<b>Project</b>	IEEE 802.16 Broadband Wireless Access Working Group < <a href="http://ieee802.org/16">http://ieee802.org/16</a> >
<b>Title</b>	CQI Signaling with Unequal Error Protection for OFDMA
<b>Date Submitted</b>	2004-6-25
<b>Source(s)</b>	Kwangjae Lim, Choongil Yeh, Hyoungsoo Lim, Yu Ro Lee, Jong-Ee Oh, DongSeung Kwon  ETRI 161 Gajeong-dong, Yuseong-gu, Daejeon, 305-350 KOREA Voice: +82-42-860-4895, Fax: +82-42-860-6732 mailto: <a href="mailto:kjlim@etri.re.kr">kjlim@etri.re.kr</a>
<b>Re:</b>	IEEE P802.16-REVe/D3-2004
<b>Abstract</b>	This document contains suggestions for the performance improvement of the CQI signaling in the uplink of OFDMA mode.
<b>Purpose</b>	The document is submitted for discussion by 802.16e Working Group
<b>Notice</b>	This document has been prepared to assist IEEE 802.16. It is offered as a basis for discussion and is not binding on the contributing individual(s) or organization(s). The material in this document is subject to change in form and content after further study. The contributor(s) reserve(s) the right to add, amend or withdraw material contained herein.

# CQI Signaling with Unequal Error Protection for OFDMA

**Figure xxx Mapping of the payload bit sequence to a FAST\_FEEDBACK channel**

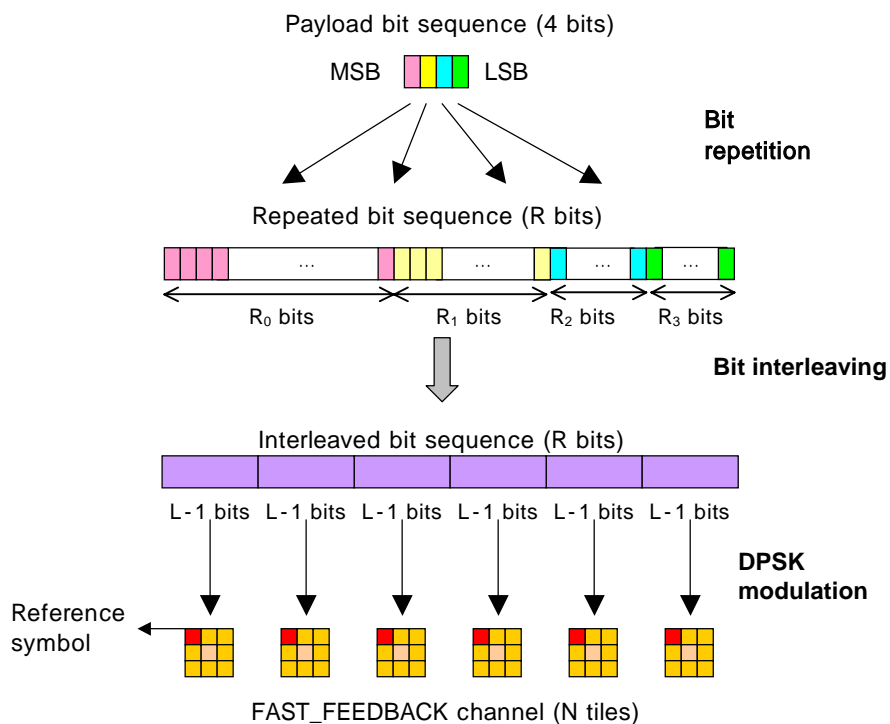
**[Insert the following text after section 8.4.5.4.10.3]**

The optional fast DL measurement feedback provides the payload bits carried by the FAST\_FEEDBACK channel with the unequal error protection (UEP) capability. The optional fast DL measurement feedback repeats each payload bit according to a predefined repetition ratio, as illustrated in Figure xxx. The repeated bit sequence is interleaved and used for binary DPSK modulation on the sub-carriers for the FAST\_FEEDBACK channel.

When the 4 by 3 uplink tile structure is used (see section 8.4.6.2.1), the number of tiles in a channel,  $N$ , is 6 and the number of subcarriers in a tile,  $L$ , is 12. When the 3 by 3 uplink tile structure is used (see section 8.4.6.5.1),  $N$  is 6 and  $L$  is 9.

Each payload bit is repeated according to the predefined UEP ratio  $R_0:R_1:R_2:R_3$ , where  $R_0$ ,  $R_1$ ,  $R_2$ , and  $R_3$  represent the repetition number for the 1<sup>st</sup> payload bit  $b_0$  (MSB), the 2<sup>nd</sup> payload bit  $b_1$ , the 3<sup>rd</sup> payload bit  $b_2$ , and the 4<sup>th</sup> payload bit  $b_3$  (LSB), respectively. A ratio of  $R_0:R_1:R_2:R_3 = 26:19:14:7$  is used for the 4 by 3 uplink tile structure. For the 3 by 3 uplink tile structure,  $R_0:R_1:R_2:R_3 =$

19:14:10:5 is used.

The repeated bit sequence is interleaved according to Equation (yyy) before binary DPSK modulation.

The interleaved bit sequence is divided into  $N$  groups and each group has  $L-1$  bits. The  $n$ -th group ( $n=0, 1, \dots, N-1$ ) is used for binary DPSK modulation on the subcarriers in the  $n$ -th uplink tile, as shown in Figure xxx. The first subcarrier in each tile is used as a phase reference. The  $L-1$  bits in the  $n$ -th group are mapped to  $L$  DPSK symbols for the  $n$ -th tile as follows.
